**Amendments to the Drawings:**

**REMARKS**

Annotated Sheet Showing Changes

FIG. 120F

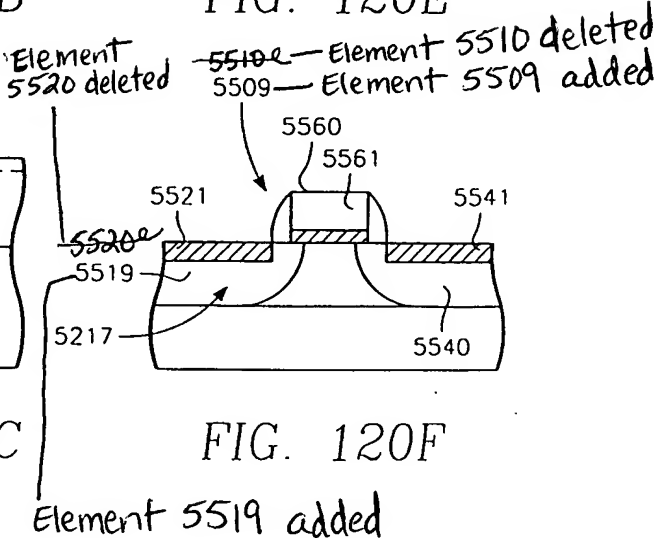
The attached sheet of drawings includes changes to FIG. 120F. This sheet, which includes FIG. 120A-120F, replaces the original sheet including FIG. 120A-120F. In Figure 120F, element numeral 5510 has been omitted and replaced with element numeral 5509, and element numeral 5520 has been omitted and replaced with element numeral 5519.

In amended drawing FIG. 120F, element numeral 5510 has been omitted and replaced with element numeral 5509. In amended drawing FIG. 120F, element numeral 5520 has been omitted and replaced with element numeral 5519.
